From: **Jon Farhat** j@jfi.net
Subject: Re: blade radius 457 mm!
Date: September 3, 2026 at 4:58 PM
To: Austin Meyer austin@x-plane.com

Regarding this… 457 blade radius. I'm a bit confused.

PROP CORE CW PCCF8 @ root 100% fill, tip 2 wall 5% fill.stl

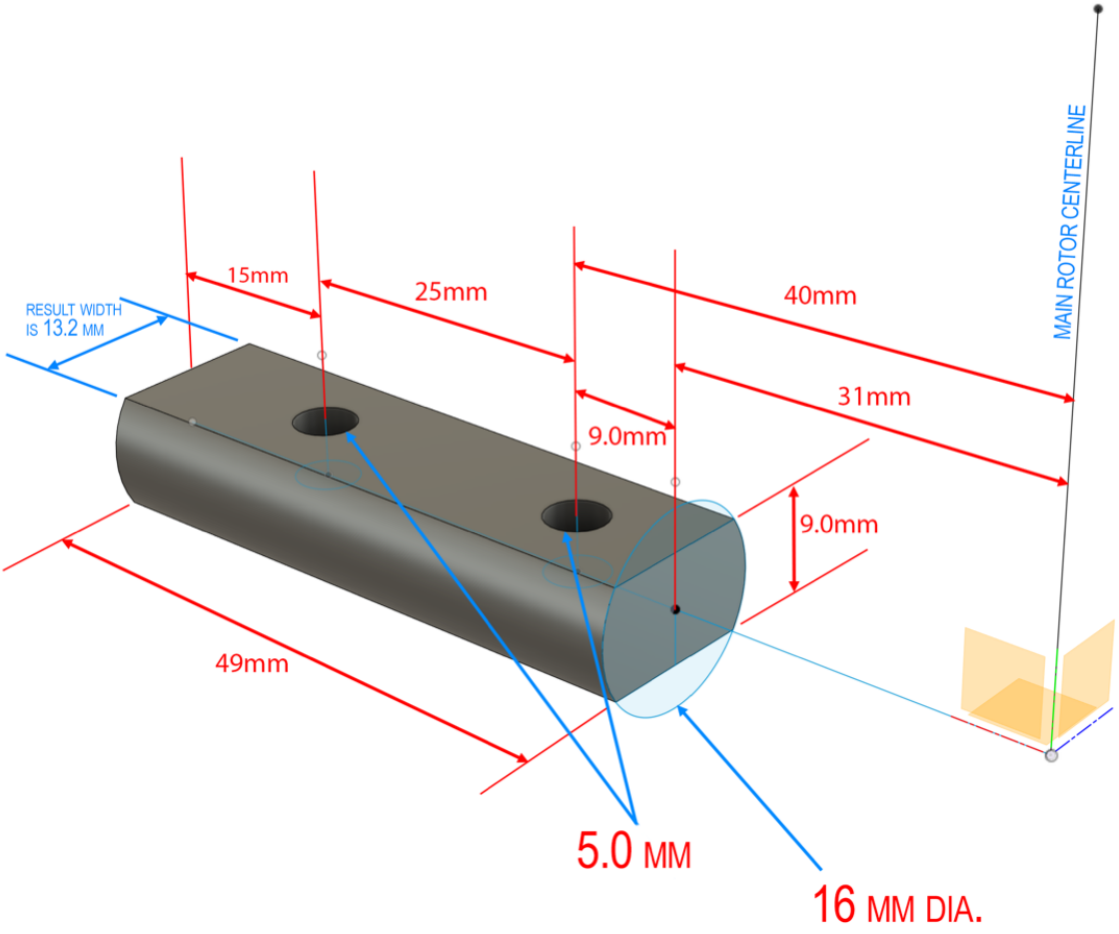
If I read the last blade STL you gave me, (attached) it's 495mm x 18.36mm x 42.6mm.

Add the 495 to the rotor head distance of 31mm to butt of blade, and you have a rotor radius of 562mm.

If it's a 'blade radius' of 457, minus the 31, it's a rotor disc radius of only 426.

Is the blade size (not blade radius) 457? If so, then add 31 to that and the true rotor disc radius is 488mm.
